TECHNICAL BULLETIN
J037NAS1
11 APR 2014

Safety Recall: Rear Sub-Frame Toe Link Nut and Washer Replacement

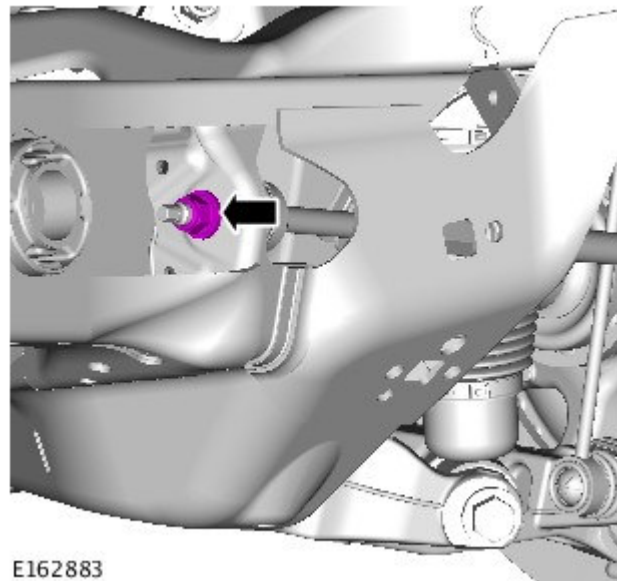
3. Install the new rear suspension toe link nut.

- TORQUE: 90 Nm
